Model: AI-C1.5	Date: 16-Dec-09	No.: RD091001a
----------------	-----------------	----------------

Subject: Firmware Release Note: Fax		Prepared by: K.Hamada	
From: 1st Overseas Tech Support Sec., 1st PQM Dept.			
Classification:	<input type="checkbox"/> Troubleshooting	<input type="checkbox"/> Part information	<input type="checkbox"/> Action required
	<input type="checkbox"/> Mechanical	<input type="checkbox"/> Electrical	<input type="checkbox"/> Service manual revision
	<input type="checkbox"/> Paper path	<input type="checkbox"/> Transmit/receive	<input type="checkbox"/> Retrofit information
	<input type="checkbox"/> Product Safety	<input checked="" type="checkbox"/> Other (Firmware)	<input checked="" type="checkbox"/> Tier 2

Model: AL-C1.5		Date: 25-May-10	No.: RD091015
Subject: Parts catalog correction		Prepared by: K. Hamada	
From: 1st Overseas Tech Support Sec., 1st PQM Dept.			
Classification:	<input type="checkbox"/> Troubleshooting	<input checked="" type="checkbox"/> Part information	<input type="checkbox"/> Action required
	<input type="checkbox"/> Mechanical	<input type="checkbox"/> Electrical	<input type="checkbox"/> Service manual revision
	<input type="checkbox"/> Pa

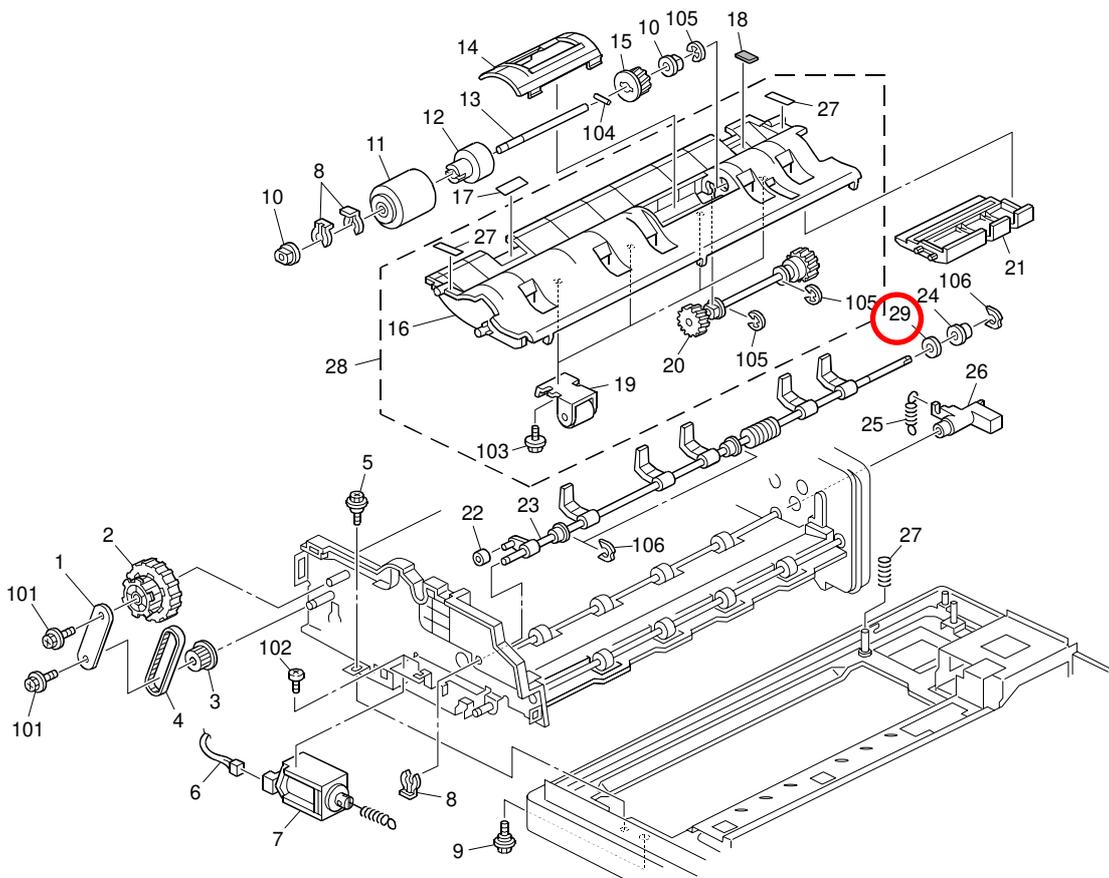
**Change:** The part in the table was added.

**Reason:** To further improve the movement of the guide (B8022226).

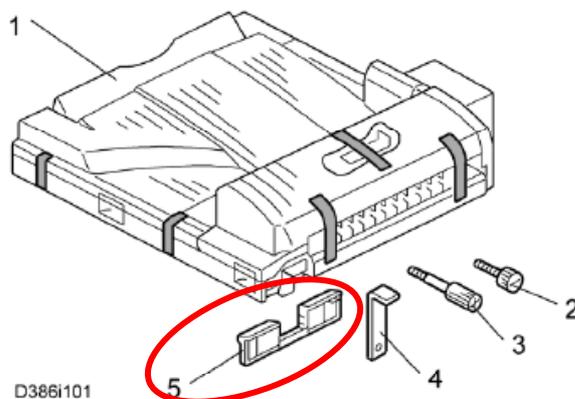
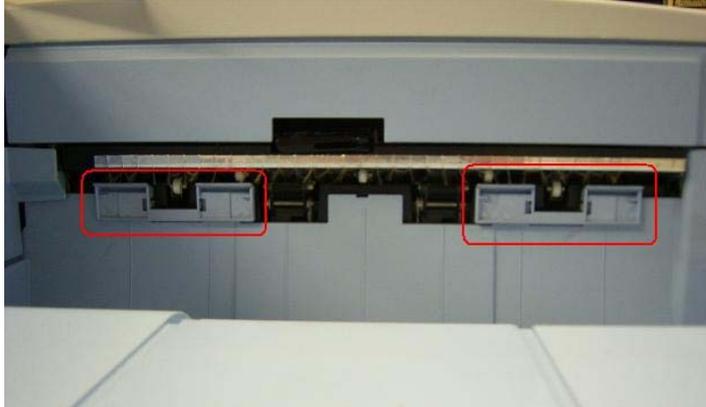
The entrance guide was not attached when the bridge unit was installed.

The following photo shows the entrance guides when they are attached to the bridge unit:

Old parts number	New parts number	Description	Q'ty	Int	Page	Index
B8022226	<b>B8022228</b>	GUIDE : REVERSE : OPEN AND CLOSE	1/1	X/O As a Set / -	25	16
AA132024	-	SPACER - M6	1/0		25	29

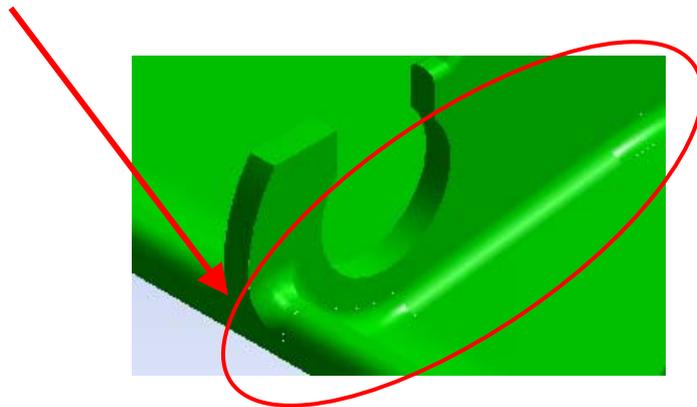
**Change:** The shape of the guide was changed (see below), and the M6 spacer was deleted.

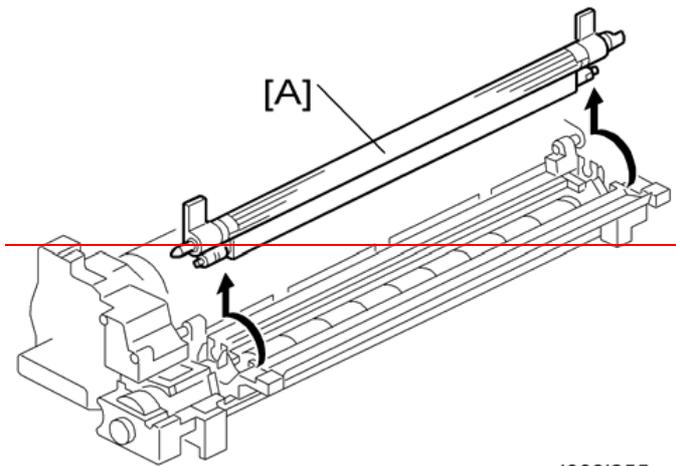
The areas ~~crossed-out~~ were **deleted**.

**Important:** If the development sleeve needs to be replaced, replace the entire development unit. This is because the PG (photoconductor gap) is a very precise adjustment that requires factory precision.

Old part number	New part number	Description	Q'ty	Int	Note
D0092105	D0092110	PCU:ALEX-C1:EXP:SERVICE:ASS'Y	1-1	O/O	-

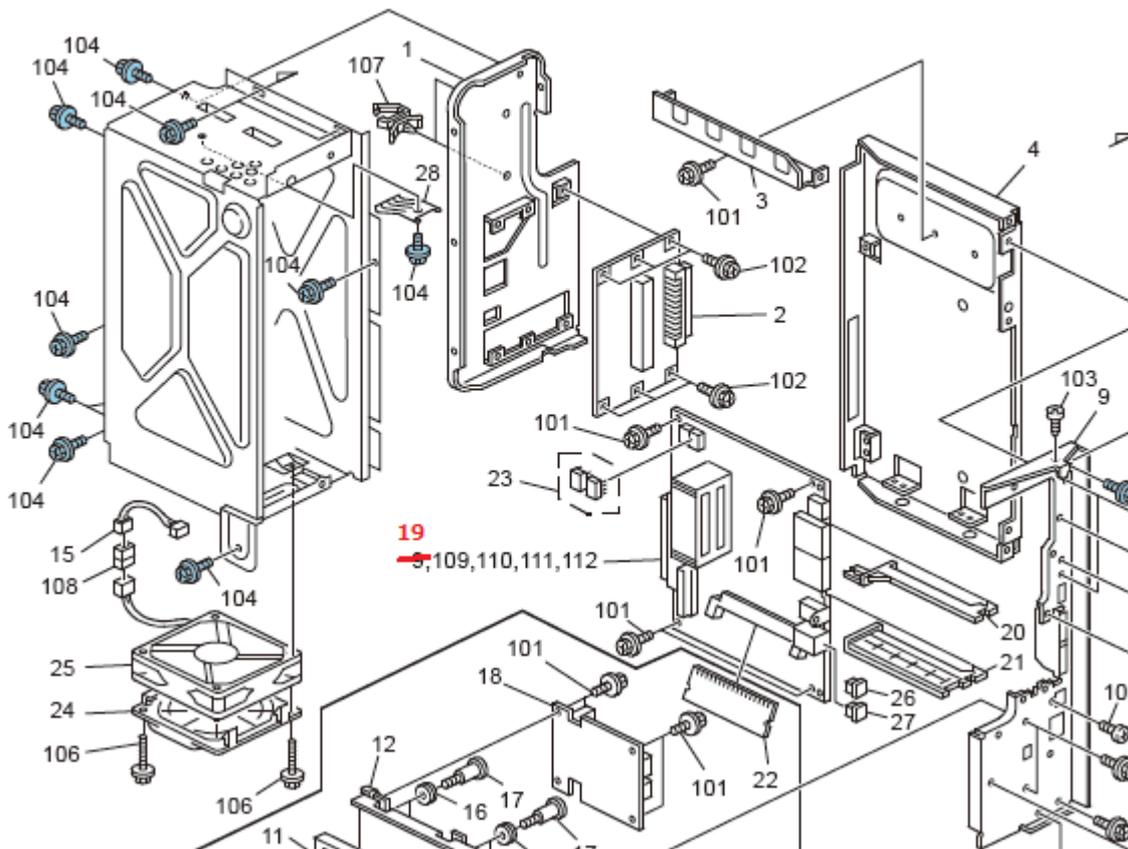
**Change:** The color of the inner cover was changed to black.  
 There is **no difference** in machine function or performance.

33.Fusing Unit 3 (D129/D130)

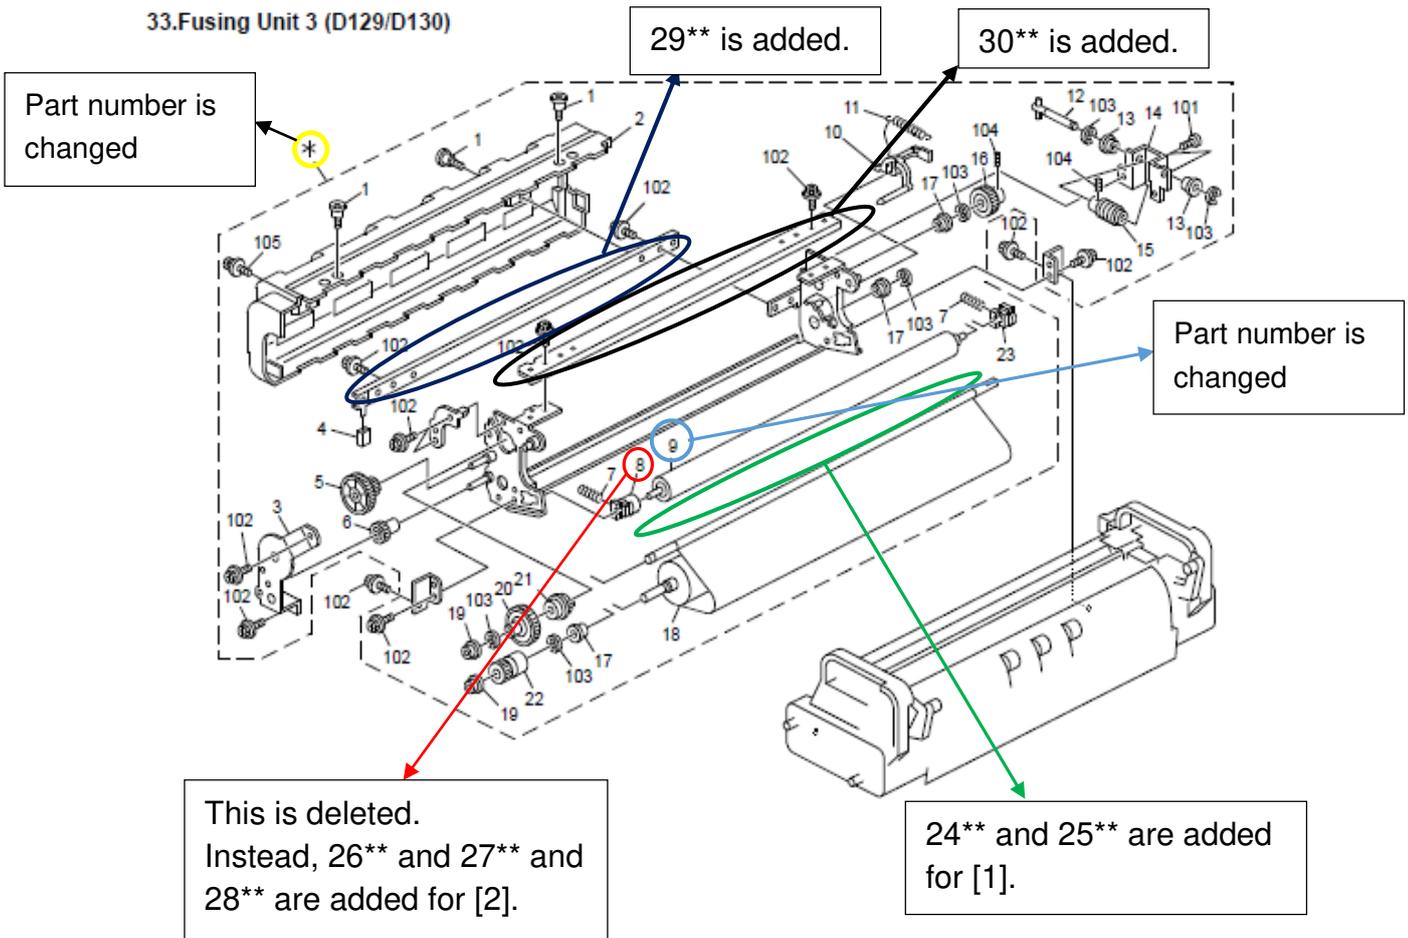
**Change/Reason:** To prevent the cleaning web from coming loose, the following parts are changed and newly added to the fusing unit.
